**CITY OF DULUTH**

**STAFF REPORT**

<b>File Number</b>	PL 14-152	<b>Contact</b>	Jenn Reed Moses, jmoses@duluthmn.gov	
<b>Application Type</b>	MU-I Planning Review	<b>Planning Commission Date</b>	April 14, 2015	
<b>Deadline for Action</b>	<b>Application Date</b>	March 18, 2015	<b>60 Days</b>	May 17, 2015
	<b>Date Extension Letter Mailed</b>	March 25, 2015	<b>120 Days</b>	July 16, 2015
<b>Location of Subject</b>	503 E 3rd Street			
<b>Applicant</b>	Essentia Health	<b>Contact</b>	John Rice, john.rice@essentiahealth.org	
<b>Agent</b>	Evan Aljoe, LHB	<b>Contact</b>	218-727-8446, evan.aljoe@lhbcorp.com	
<b>Legal Description</b>	PID 010-3830-10380			
<b>Site Visit Date</b>	November 5, 2014	<b>Sign Notice Date</b>	March 30, 2015	
<b>Neighbor Letter Date</b>	March 31, 2015	<b>Number of Letters Sent</b>	13

**PLANNING COMMISSION FILE NUMBER PL 14-152  
ESSENTIA HEALTH GENERATOR BUILDING**

1 SOUTH ELEVATION  
1/8\"/>

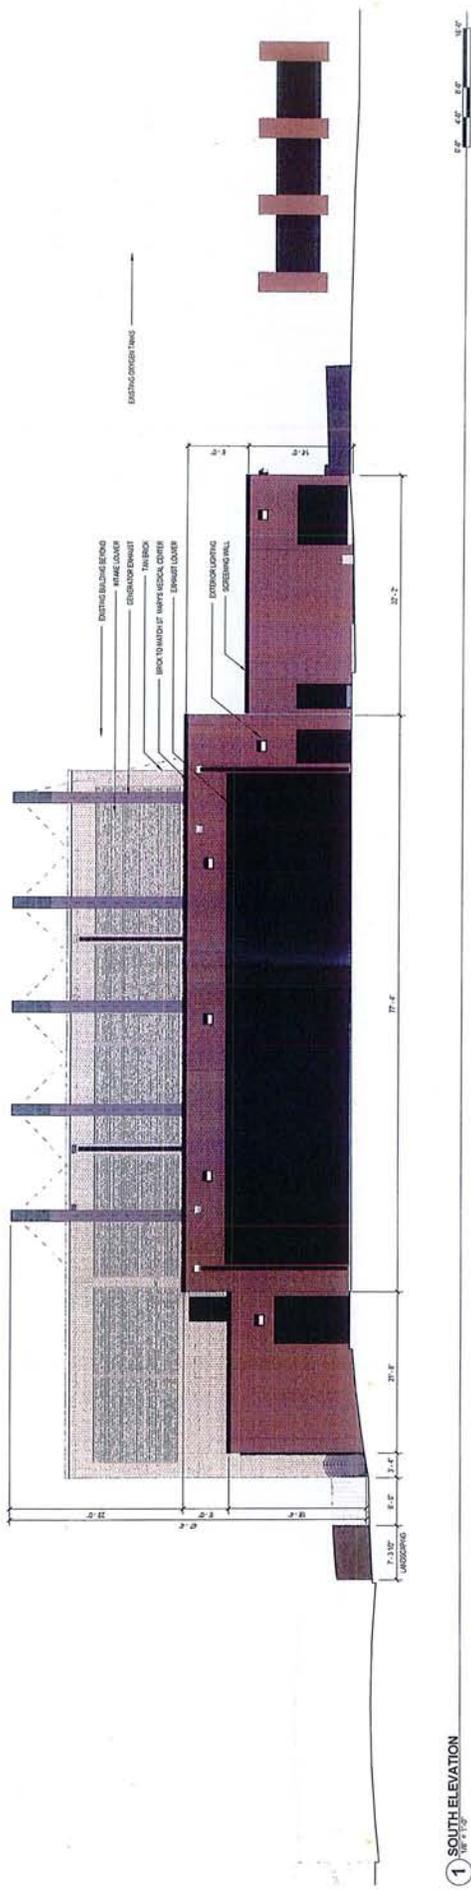
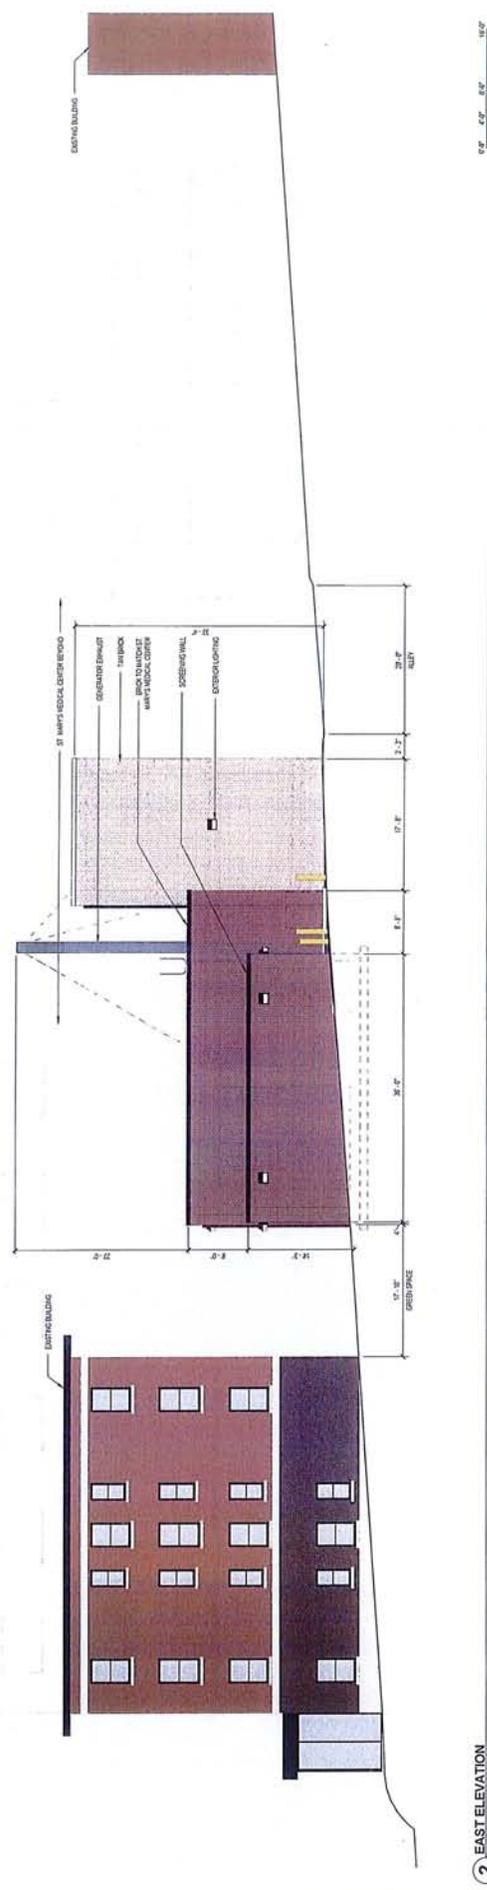
As indicated on Sheet A3.1 of the submitted drawings (attached), the approved plan included a 25'-4" tall north building mass, which would be clad in light tan brick. In addition, the approved plan also included 43'-4" tall exhaust stacks.

Over the course of sound modeling, it was determined that locating the intake louvers on the north face of the building would not provide sound levels that met Minnesota Rule 7030. As a result, we are proposing that the intake louvers would be located on the south face of the north building mass, allowing the sound levels to meet the code, but requiring a building height of 36'-0" and exhaust stack height of 47'-4" (please see attached PDF). As shown by attached sheets A3.1 and A3.3, the scale of the building remains in line with the adjacent buildings, and is well short of the 120 foot maximum allowed by the UDC.
